ADDENDUM NO. 2

COUNTY OF VENTURA REQUEST FOR PROPOSAL NO. 5737 CREATING, FABRICATING AND INSTALLING A INTERACTIVE CHILDREN'S EXHIBIT ON AIR QUALITY

February 28, 2014

County of Ventura Request for Proposals #5737 Creating, Fabricating and Installing a Interactive Children's Exhibit on Air Quality QUESTION AND ANSWER #1

Museum Map

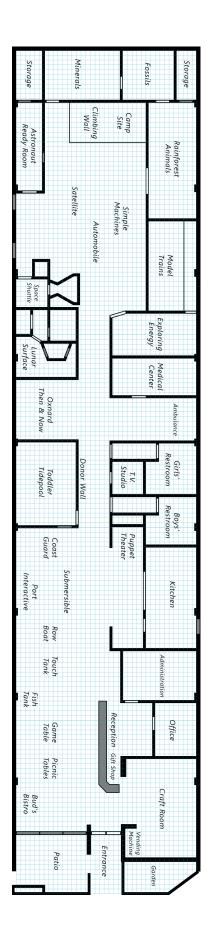
4. Question: Do you have floor plan for the exhibit space? Locations of doors,

openings, windows, ceiling lighting and electrical outlets?

8. Question: Are there any elevations for the room the exhibit will be going

into?

Answer: Floor plans attached. Please focus on the "Minerals" room

between "Storage" and "Fossils." The room's dimensions are exactly 10' X 16' with a ceiling of 9'. There are some 40" deep cabinets on the "Fossil" end which can be removed. The 2 doorways are standard 29" wide and 79" tall. The door on the "Fossil" end is 27" in from the inside wall (the wall with the

"Climbing Wall" on the opposing side.")

Answer: Please refer to Exhibit C.
